Appeal against approval of DP2014-1557 at 55 - 28th Avenue SW

I'm here on behalf of the Erlton Community Association. We fully support Mr. Turner in his appeal against this discretionary development.

3
DP6

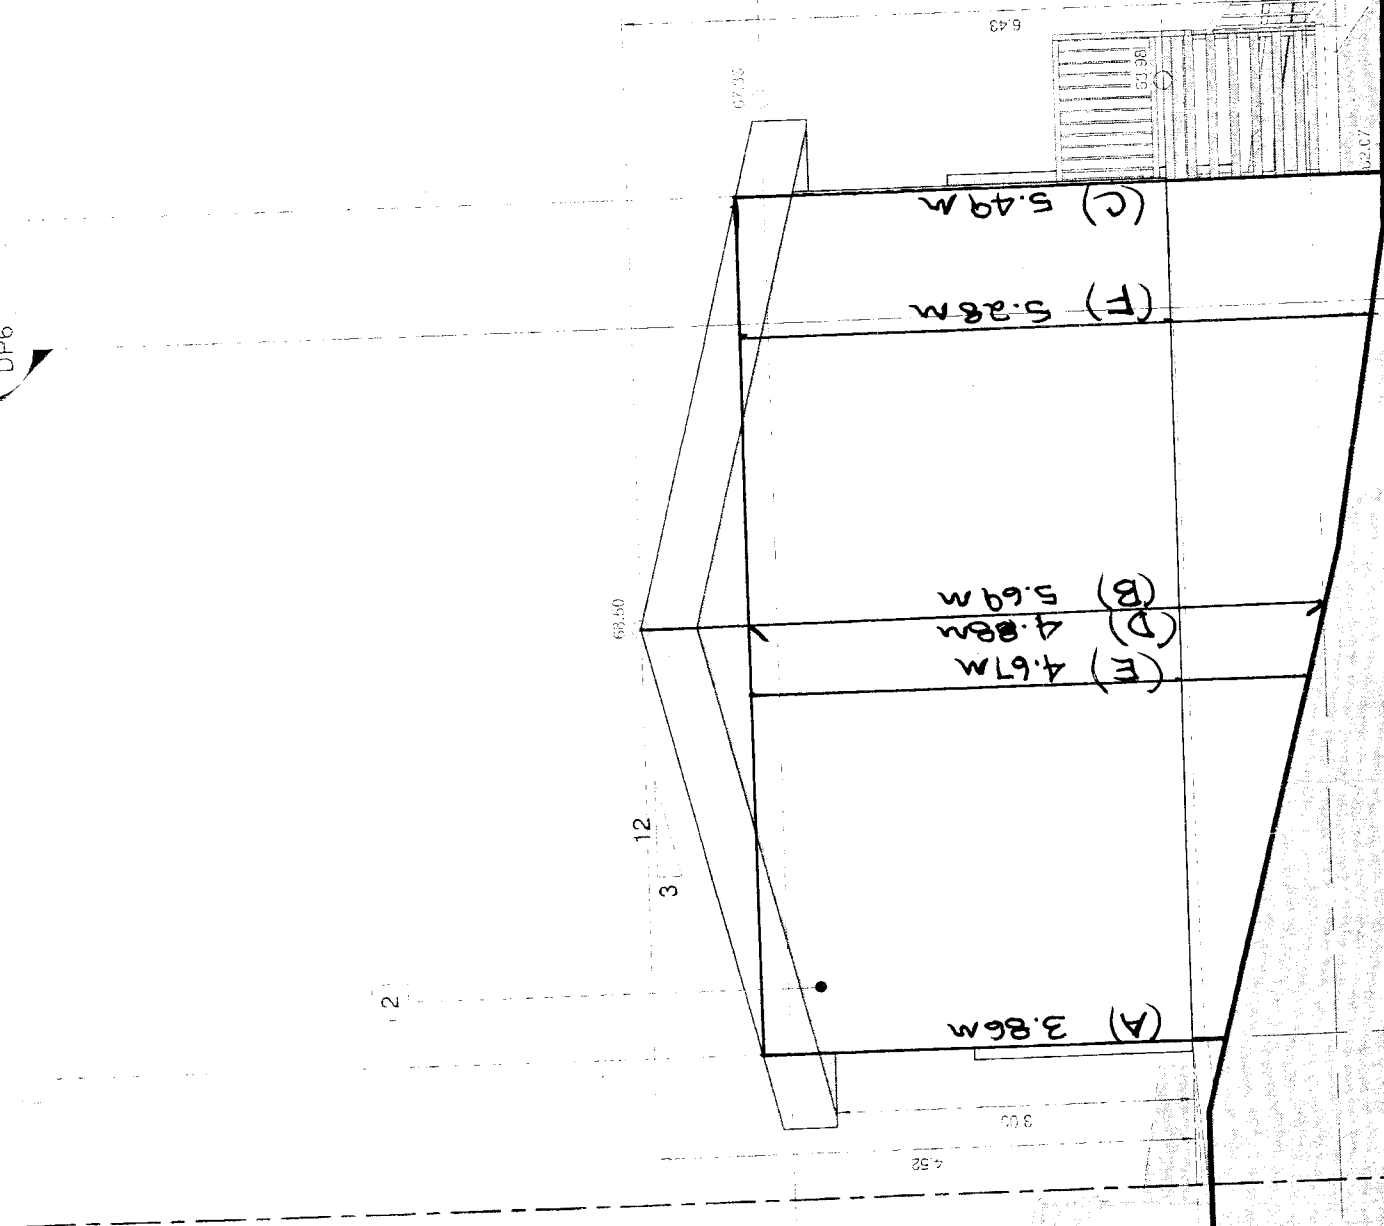
Plan DP6, bottom right corner, shows the garage ceiling height as 11 feet 1 inch, or 3.38m.

Drawing #5 shows a large improvement when an 8-foot ceiling height is coupled with a .5/12 roof pitch, a 1.2m side setback, and a 6.0m garage depth. It results in a noticeable reduction in shadowing to the rear yards of both homes.

SHADOW FROM APPROVED

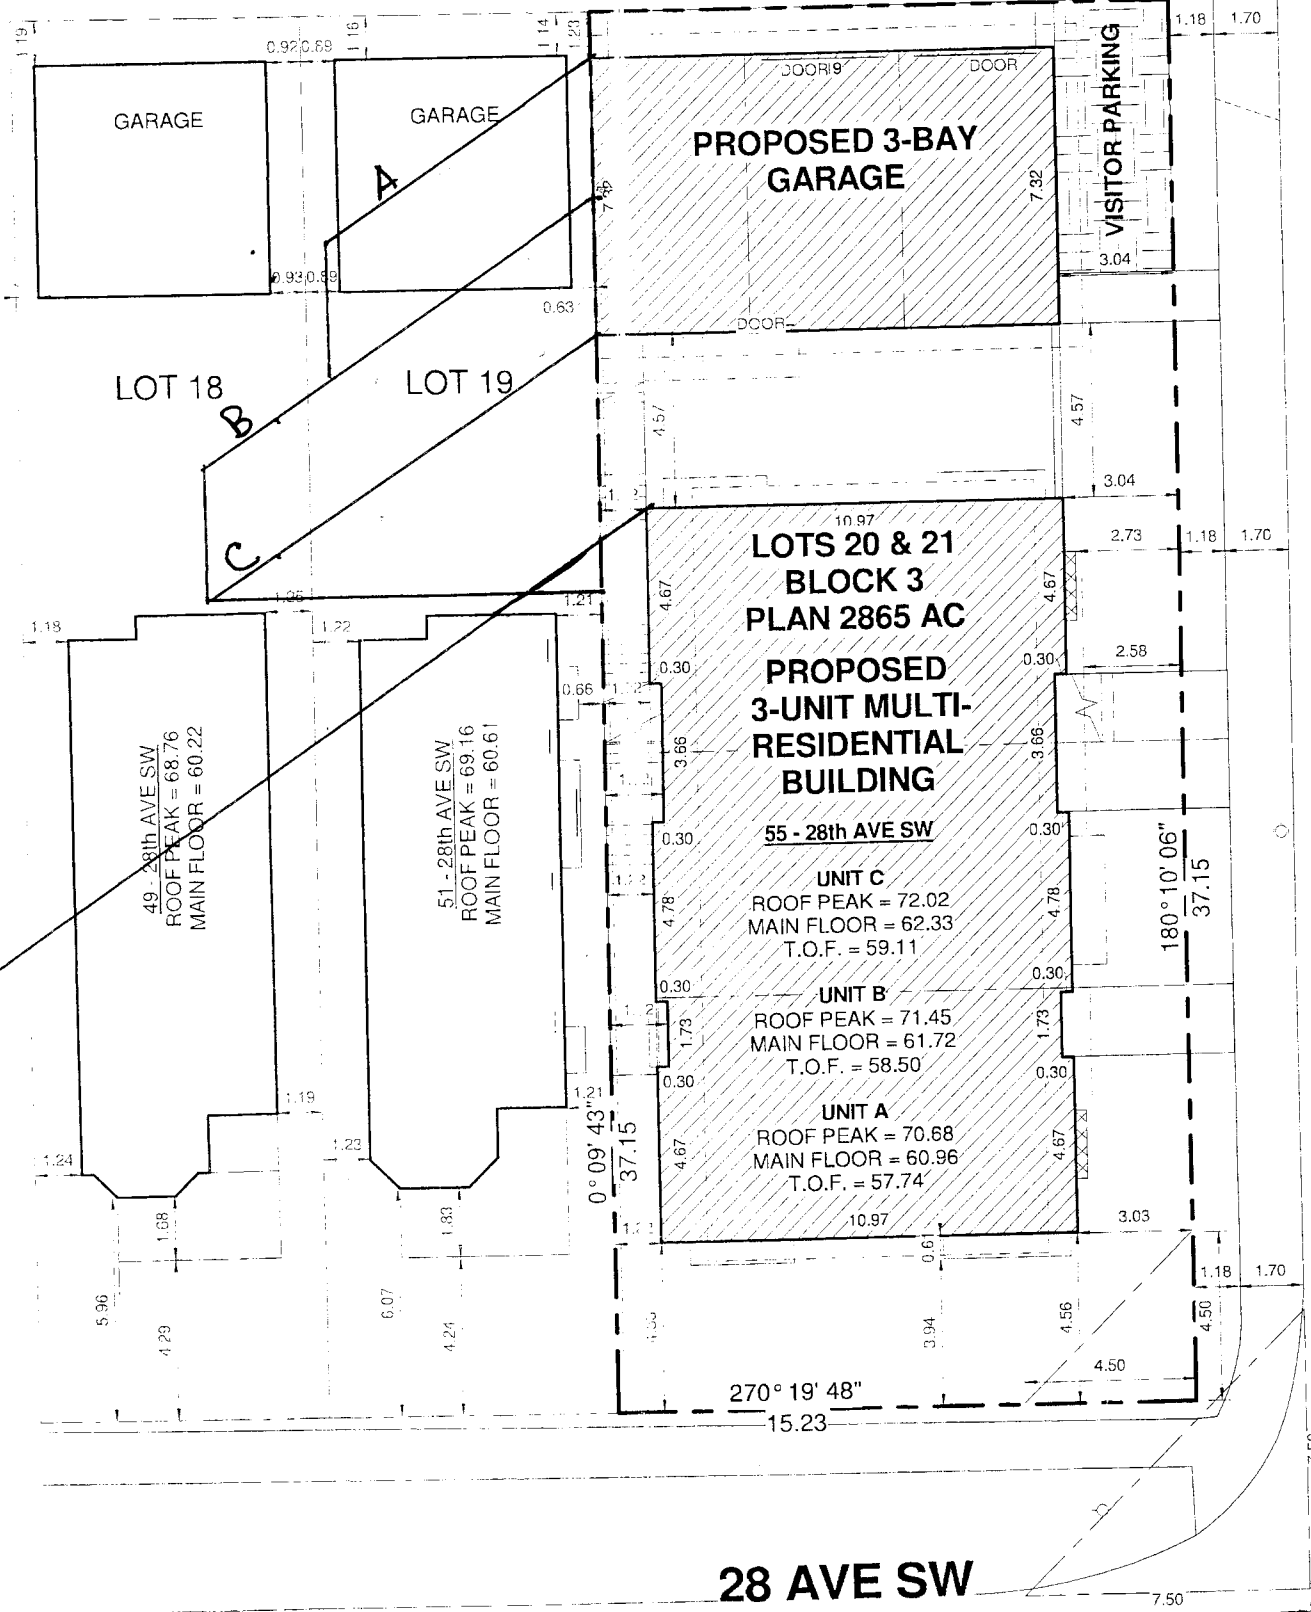
Drawing #1 shows the shadow cast by the garage, as approved, displayed on plan DP1. This is a massive imposition on the use and enjoyment of Mr. Turner's home, and has a substantial impact on Mr. Stanic's home.

A: Plan DP5 shows the south-east corner roof height at 3.86m above grade.

B: Plan DP5 shows the roof peak height at 5.69m above grade.

C: Plan DP5 shows the north-east corner roof height at 5.49m above grade.

SHADOW WITH .5/12 PITCH.

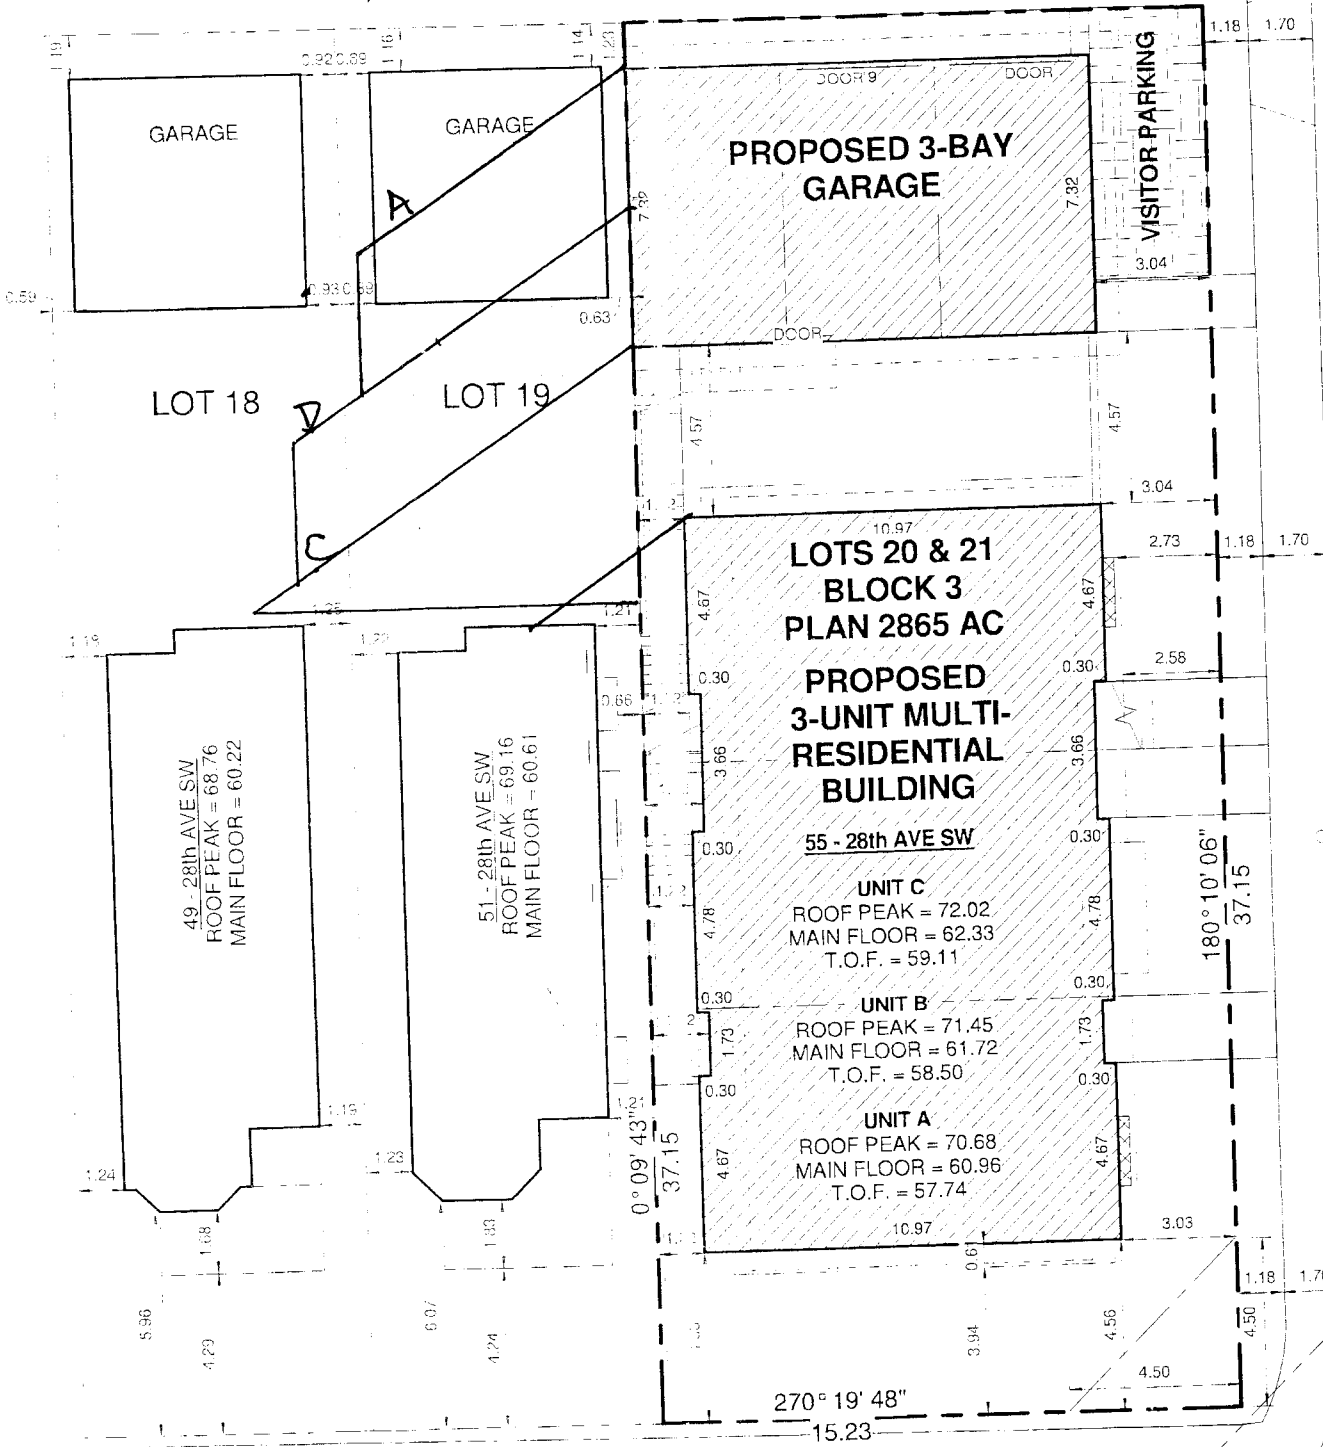
Drawing #2 shows that changing just the pitch of the roof to .5/12 to match that of the main building does little to reduce the shadowing except on Mr. Stanic's rear yard.

SHADOW WITH
 .5/12 PITCH &
 1.2M SETBACK

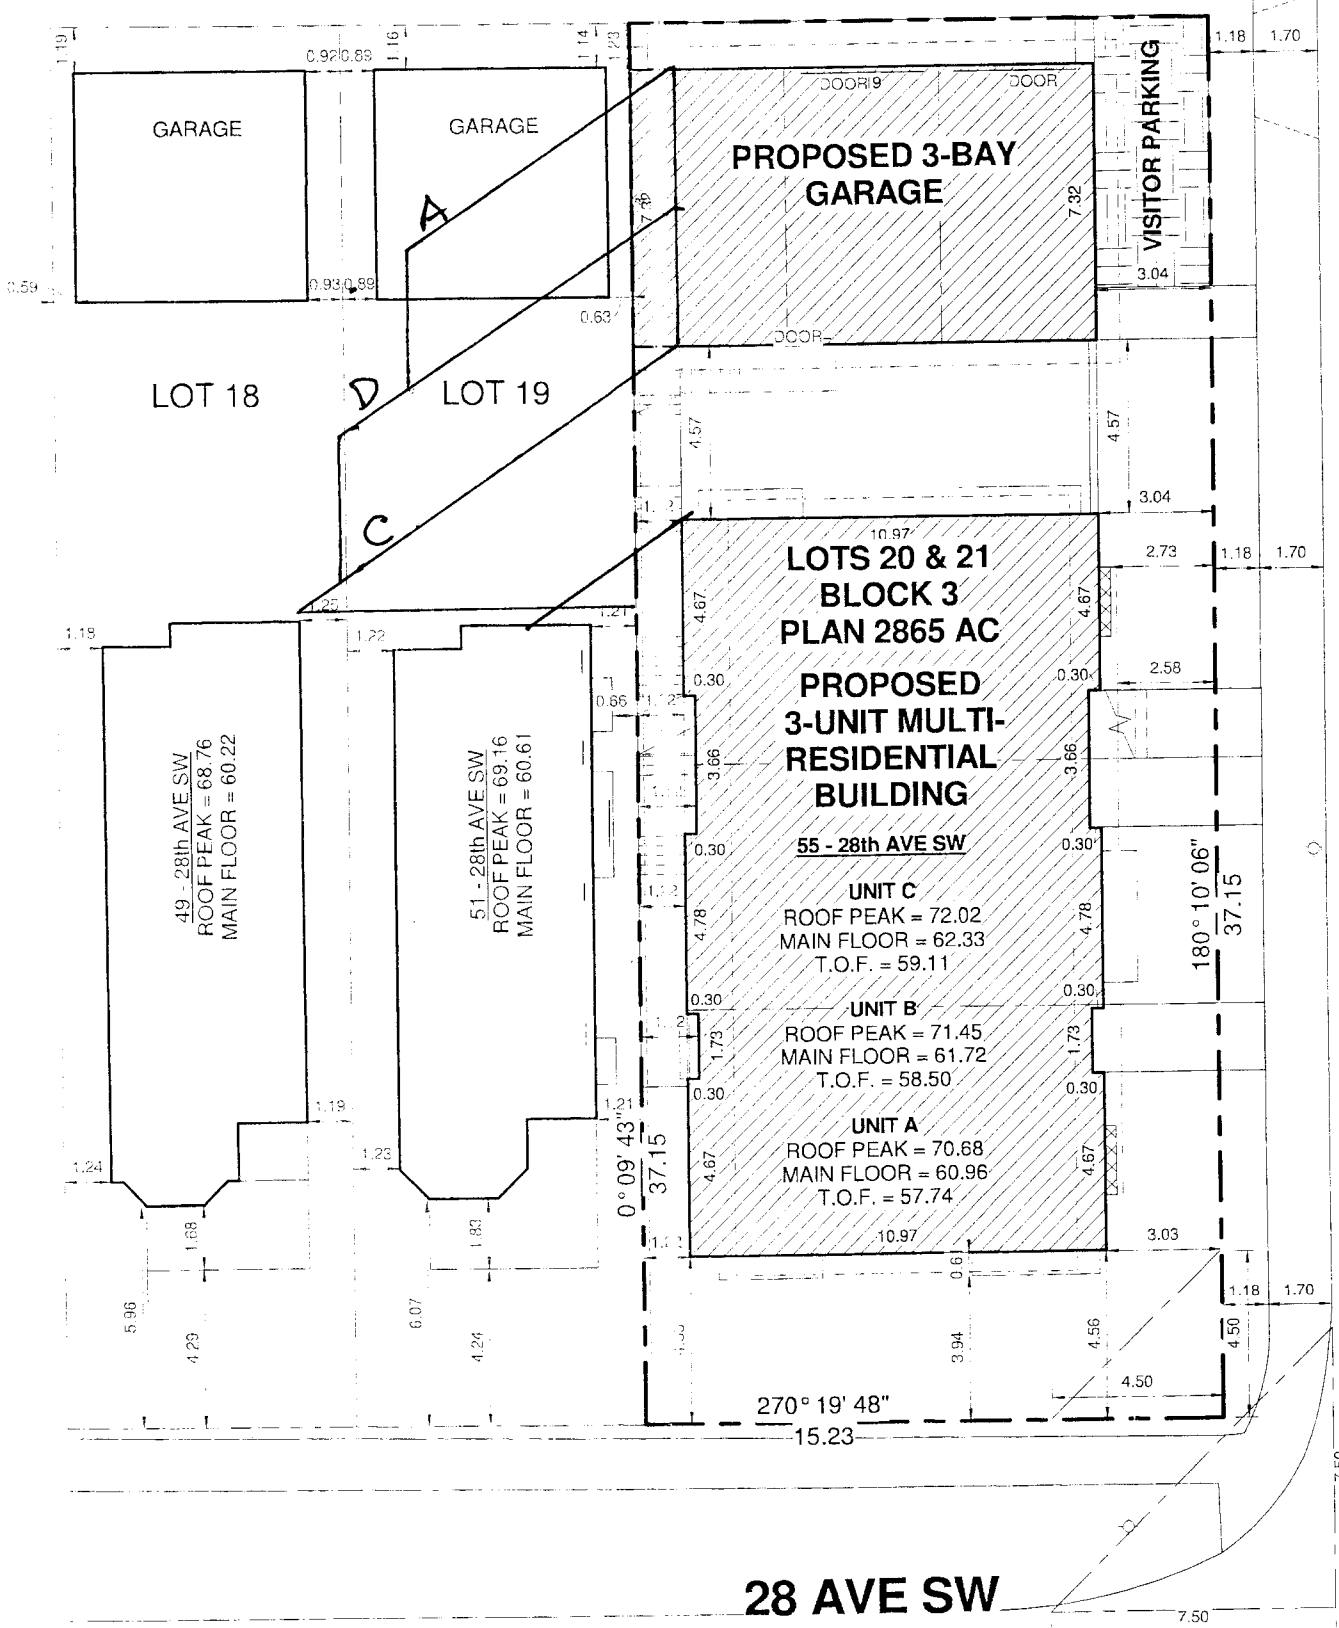
Drawing #3 shows that changing both the roof pitch and implementing a 1.2m setback from the property line again does little to reduce the shadowing except on Mr. Stanic's rear yard.

SHADOW WITH
 .5/12 PITCH
 1.2 M SETBACK
 6.0 M DEPTH.

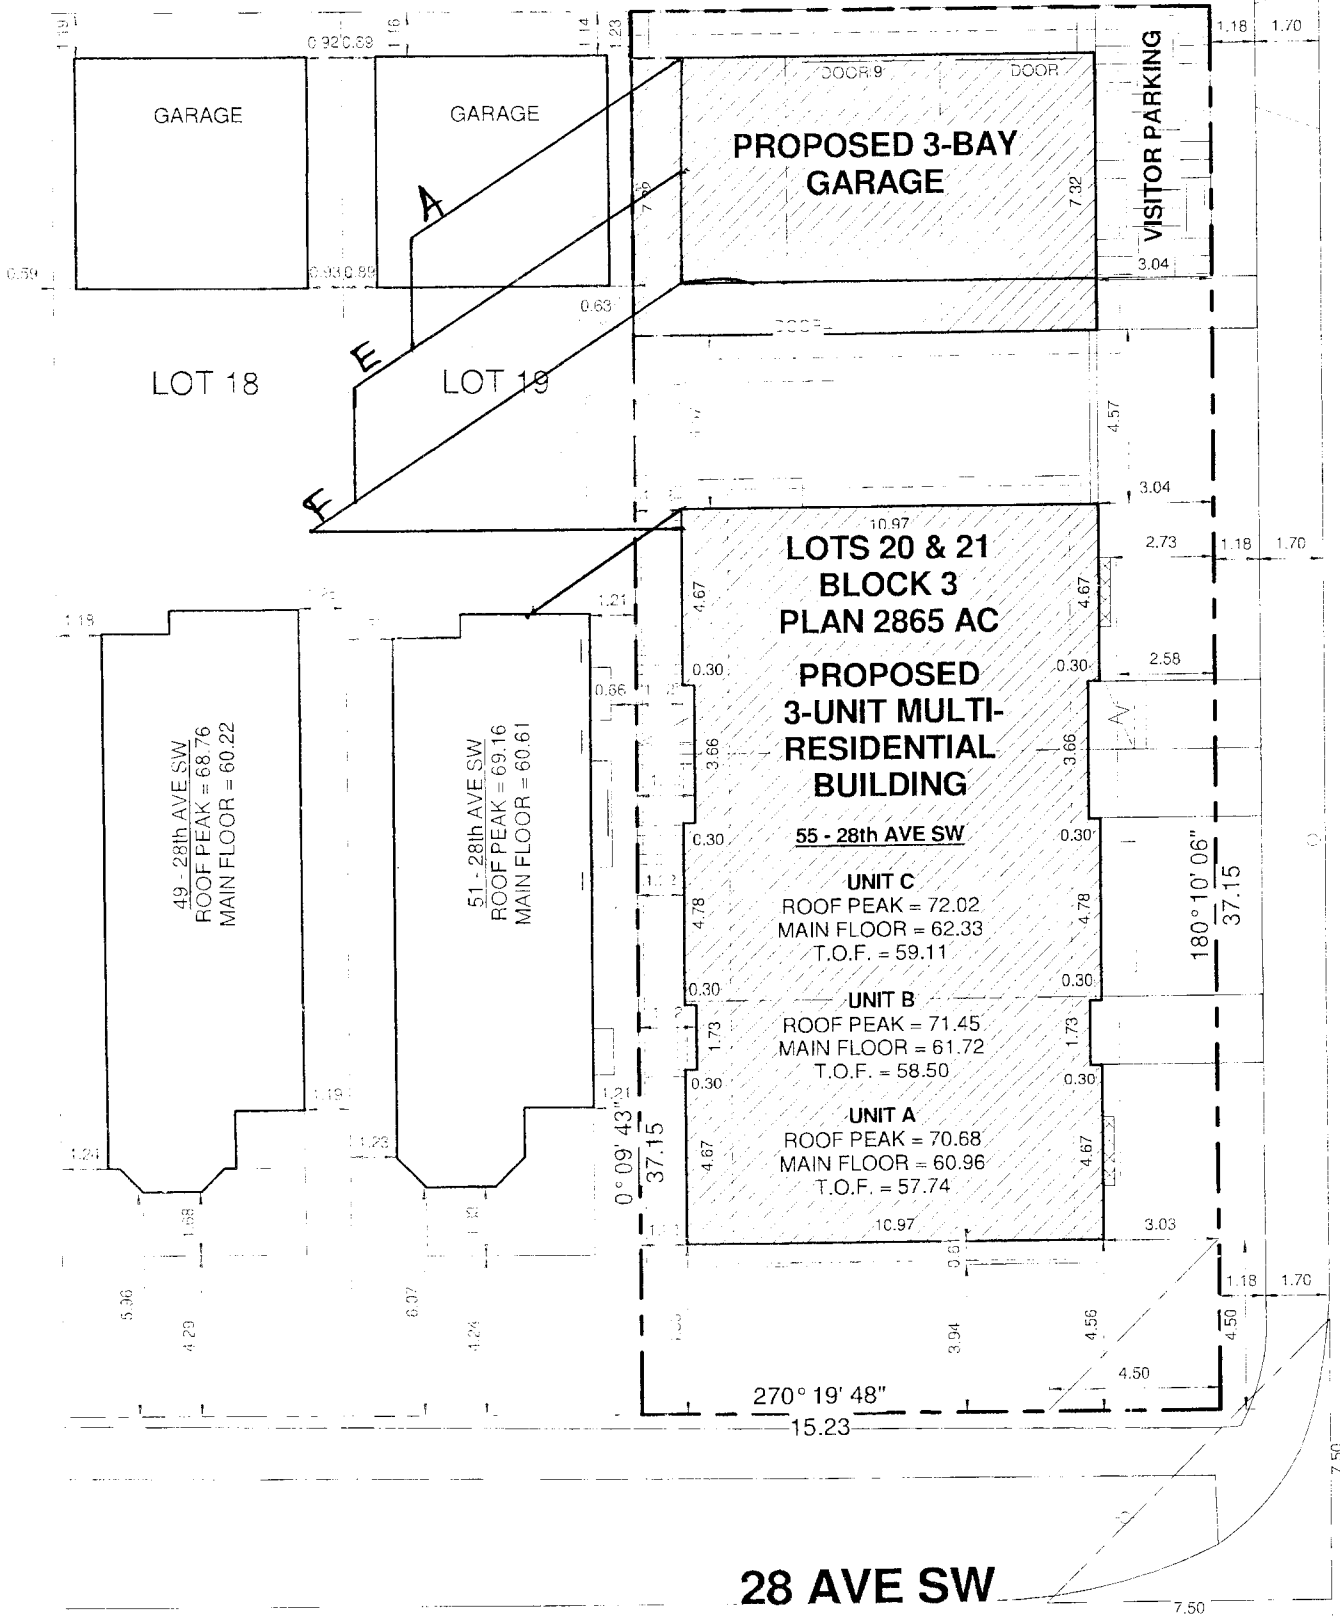
Drawing #4 shows that some improvement occurs with a .5/12 roof pitch, a 1.2m side setback, and a 6.0m depth similar to the garages to the east.
